## ADDENDUM

NO. 02

**PROJECT NAME:** 2024 Cy Ranch High School Additions And Renovations

**ADDENDUM DATE:** Thursday, November 20, 2024

1 NEW OVERFLOW ROOF DRAIN @ EXISTING ROOF  
1 1/2" = 1'-0"

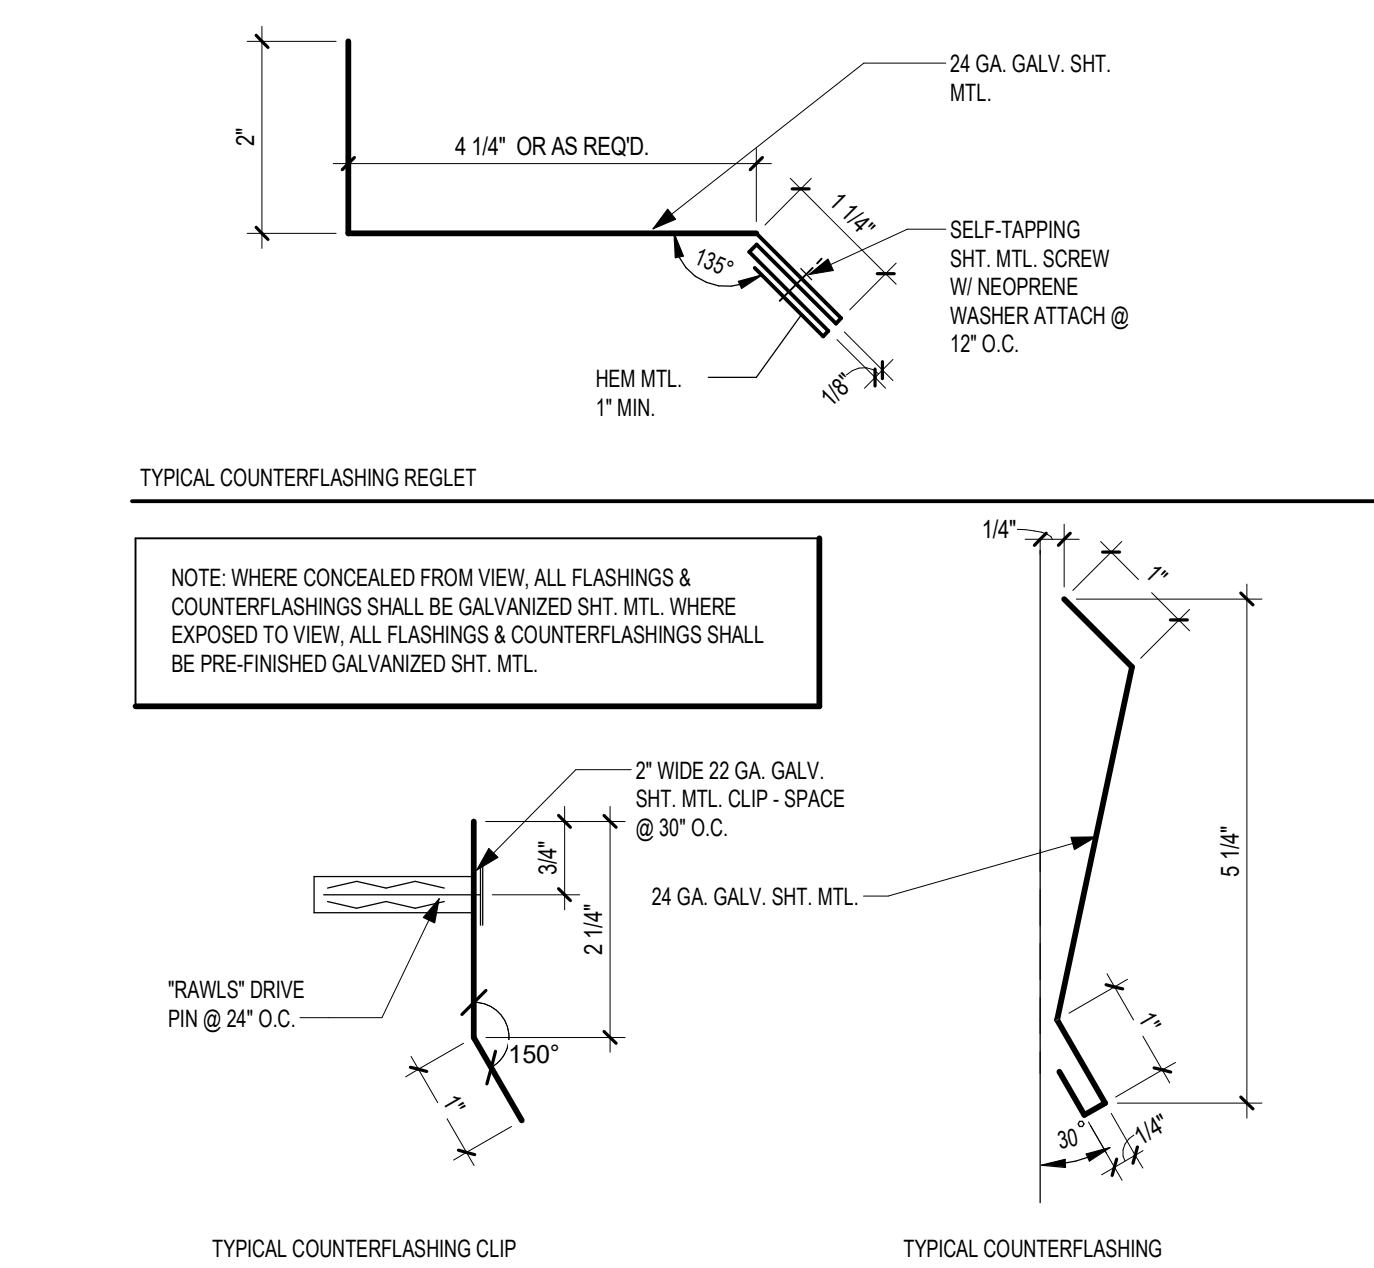
- 4) Details 1, add detail per attached sheet.

8 A7-ROOF MINI-SPLIT THRU ROOF - ENLARGED  
3" = 1'-0"

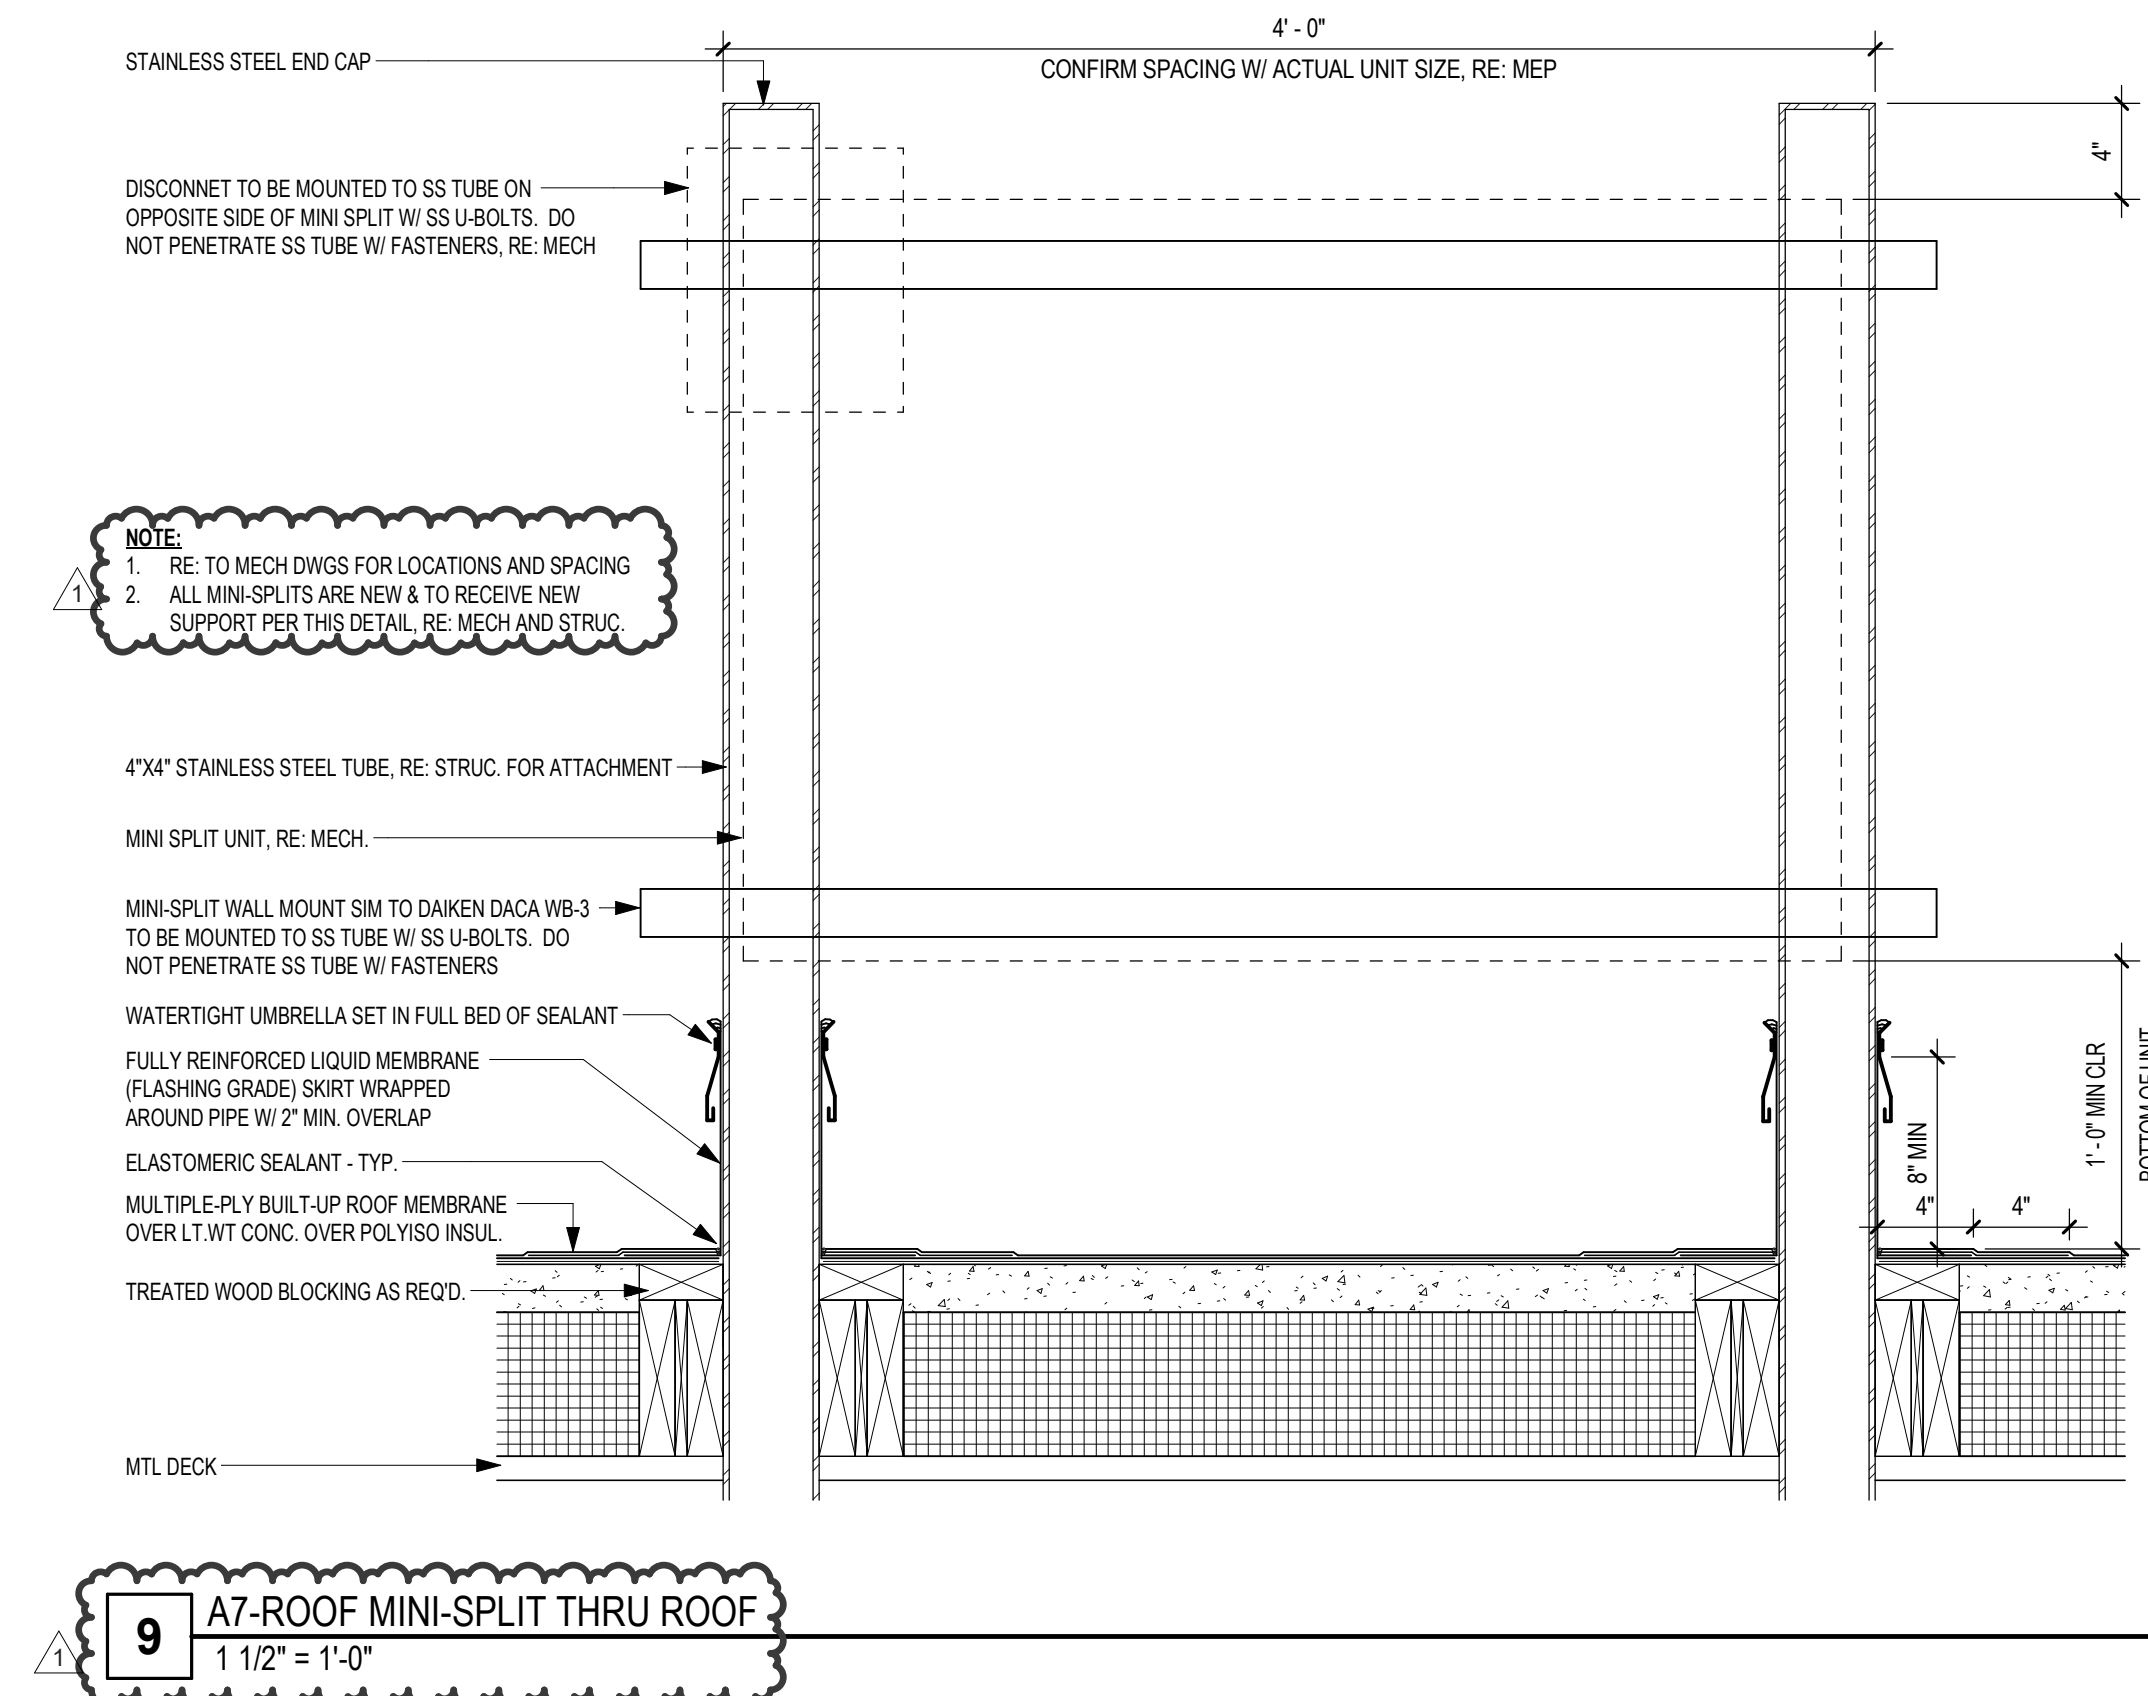
- 5) Details 8 & 9, revise detail "NOTE" and detail title per attached sheet.

**3 ROOF ACU SUPPORT DISCONNECT**  
 Scale: NOT TO SCALE

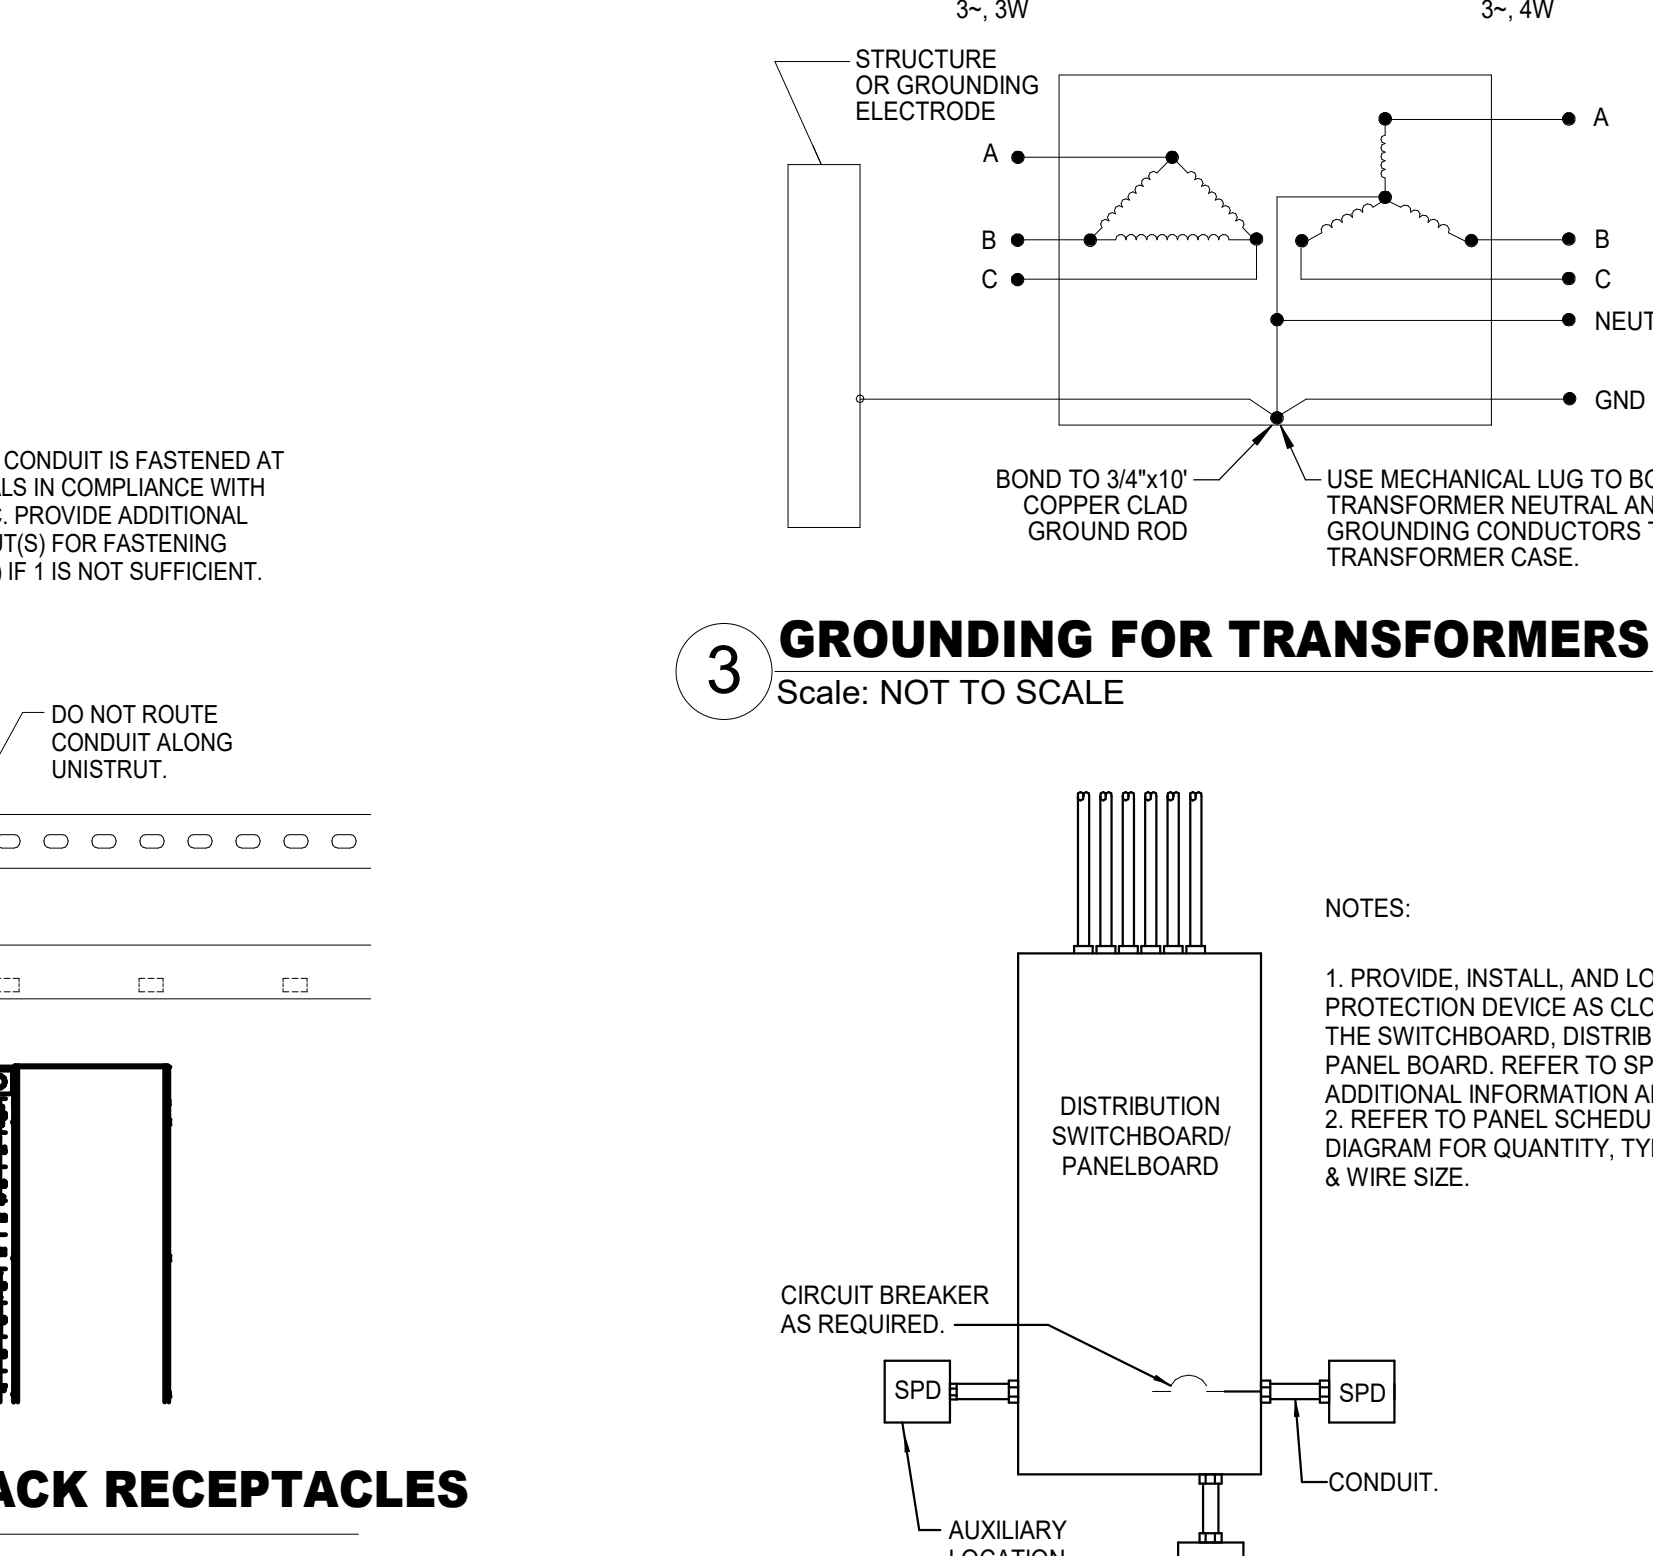
AD No 2, Elec. Item 3: **To the Drawings, Sheet E8.01, "ELECTRICAL DETAILS, LEGENDS, AND SCHEDULES,"**  
Refer to attached drawing E8.01 for addition of auditorium strip aisle lighting fixture type to luminaire schedule and added 'ROOF ACCU SUPPORT DISCONNECT' detail.

Job No. 01818-05-01	Sheet No.
Drawn By: YU	<b>P3.02</b>
Date: 11/11/2024

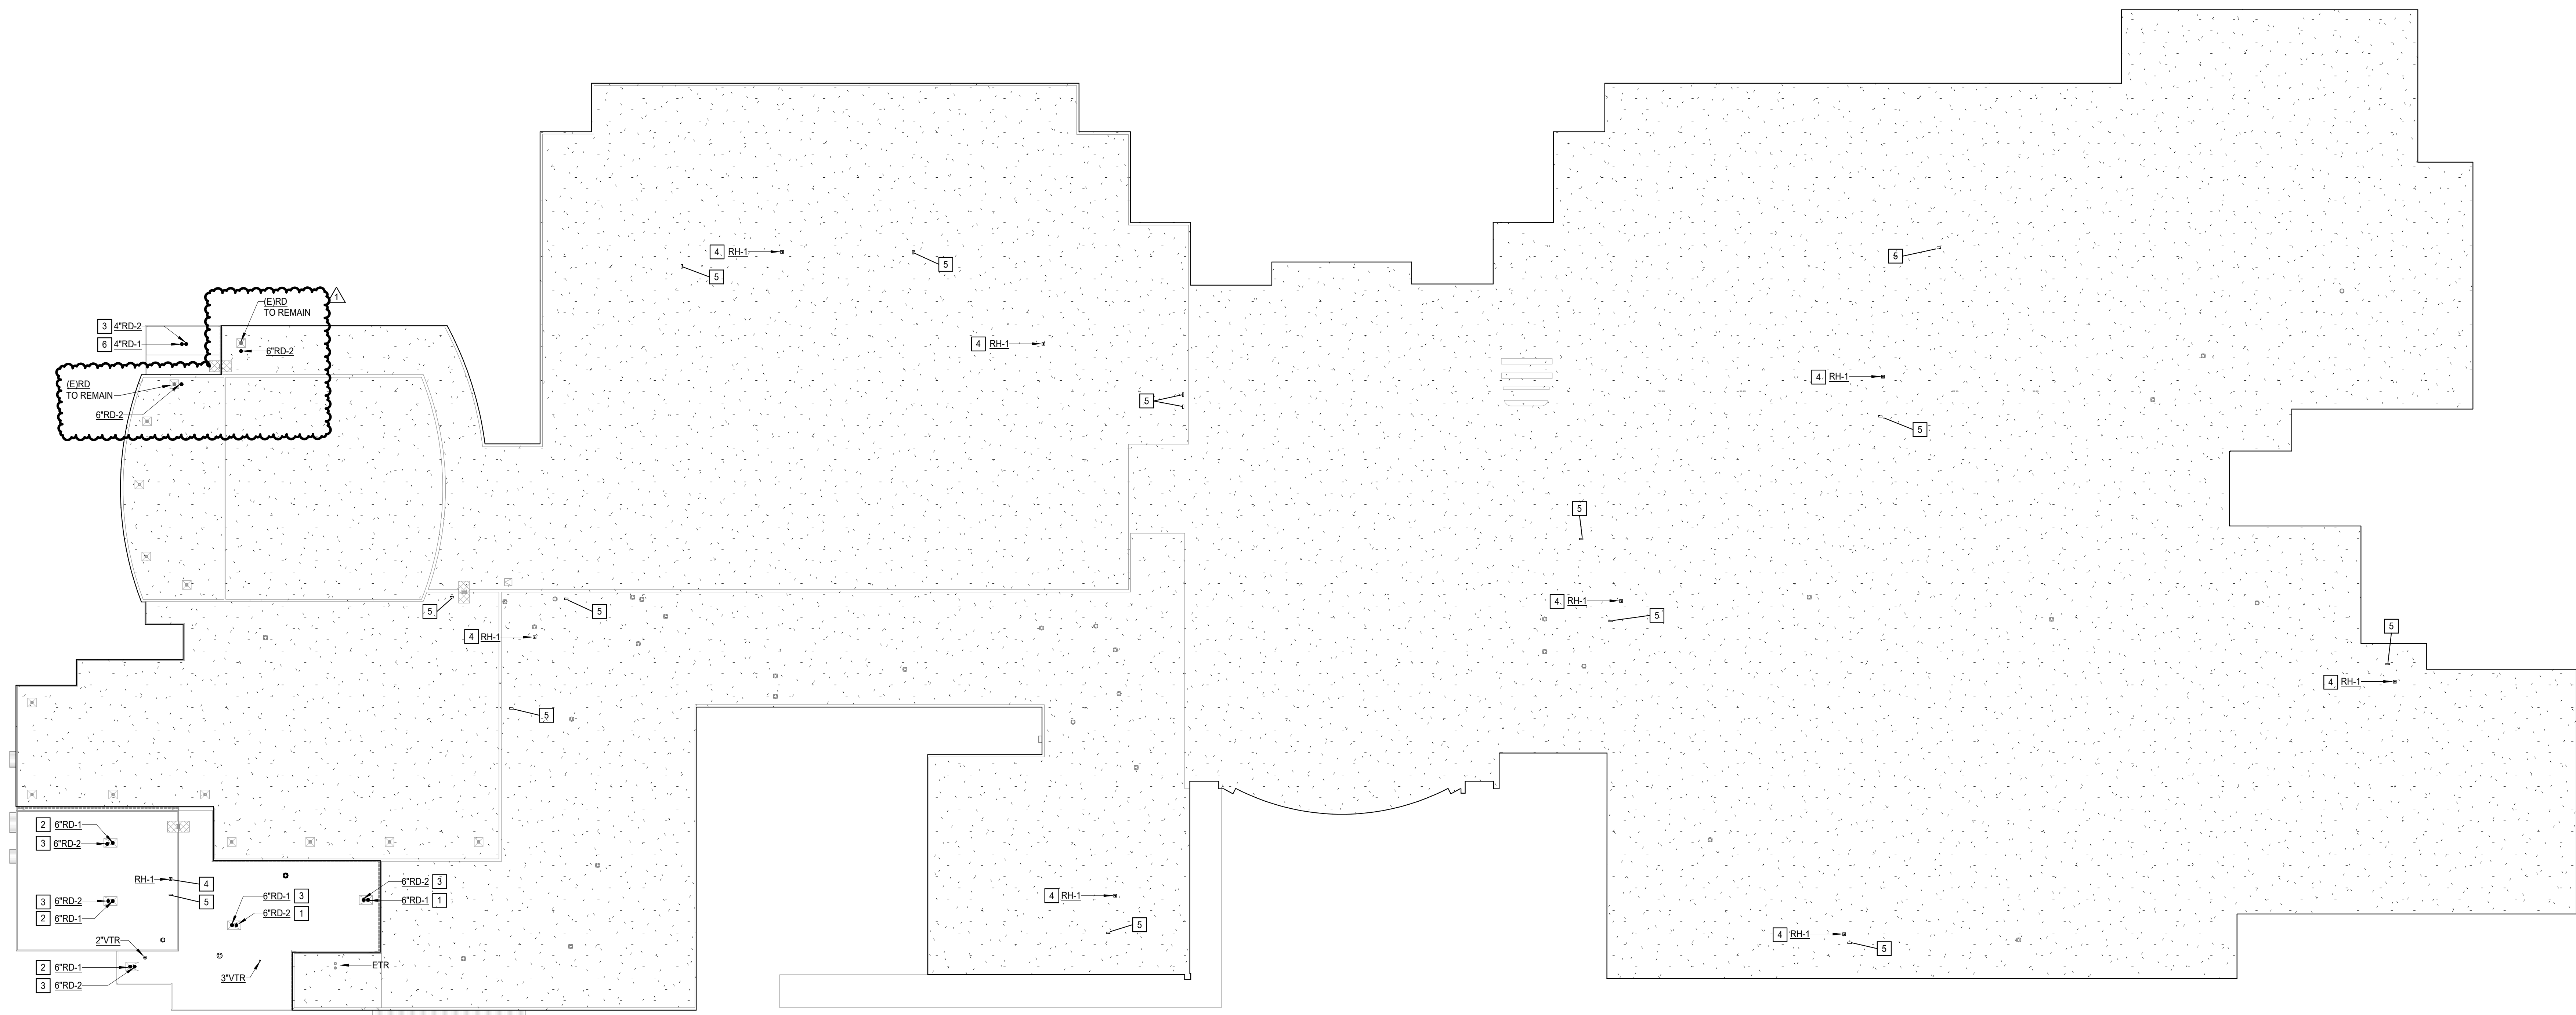
- a. Added wall hydrant outside Mech G167.
- b. Relocated shutoff valve for sinks in Digital Art G154.
- c. Refer to attached drawing P3.02.
